UNITED STATES PATENT AND TRADEMARK OFFICE

10/760,253

Office Action Summary	Application No. 10/760,253	Applicant(s) SILVERBROOK ET AL.	
	Examiner LAURA E. MARTIN	Art Unit 2853

DETAILED ACTION

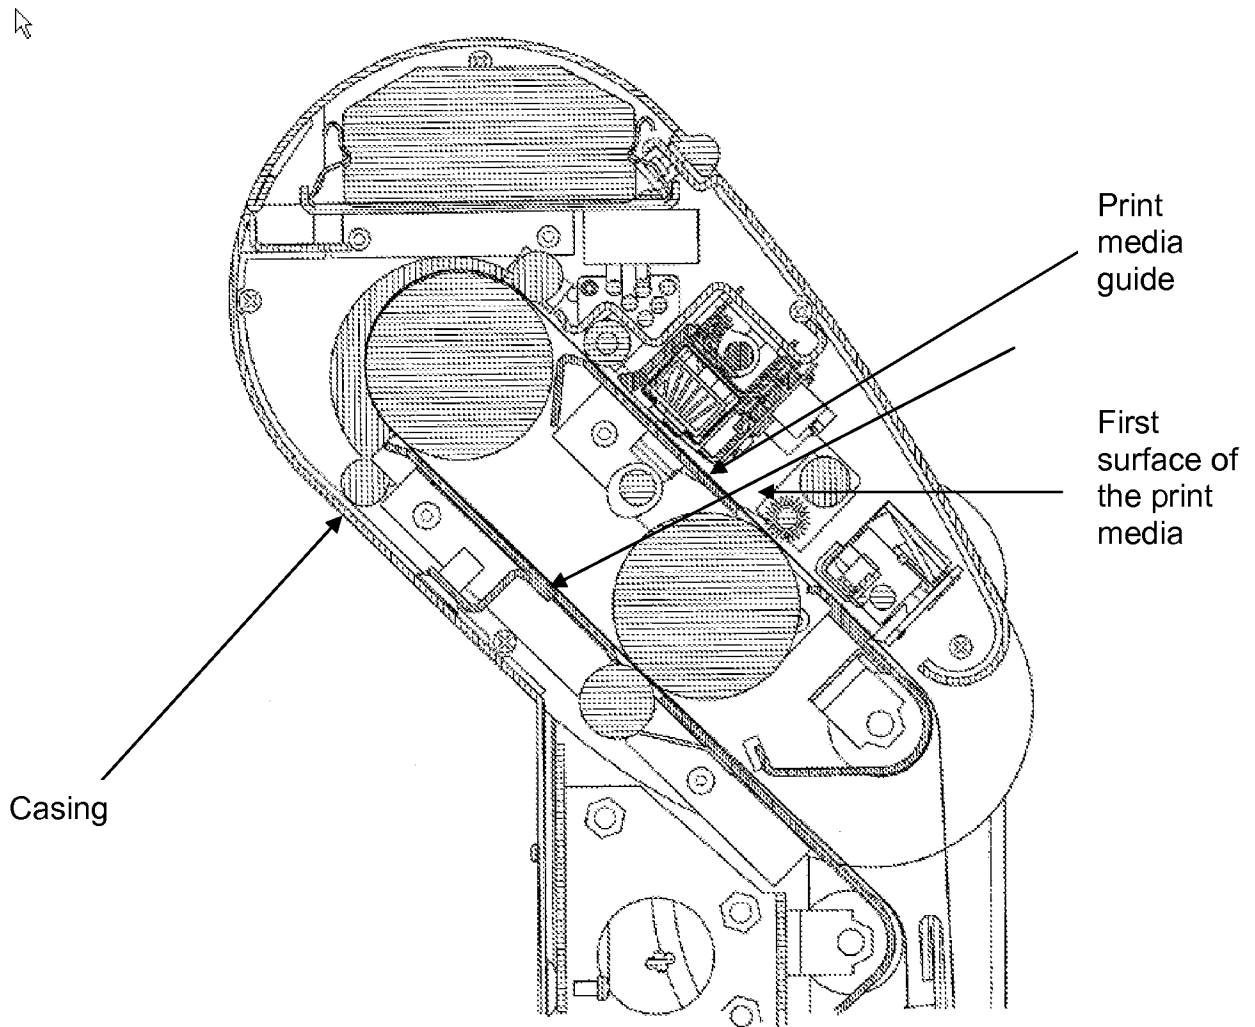
As per claim 1: a casing in which the at least one printhead module is removably mounted a print media guide mounted to a slanted portion of the casing immediately adjacent the printhead module, a slanted print media contact surface of the print media guide arranged to contact and guide the print media across the nozzles of the printhead module for printing onto the first surface (shown below).

As per claim 2: a print media guide is arranged to substantially prevent the print media from impinging on the nozzles of each of the at least two printhead integrated circuits (see figure below – media guide and rollers put pressure on paper so that it rests against the media guide and not the nozzle area).

As per claim 3: the print media guide is arranged to provide a gap between the nozzles of each of the at least two printhead integrated circuits and the passing print media (see figure below – media guide and rollers put pressure on paper so that it rests against the media guide and not the nozzle area).
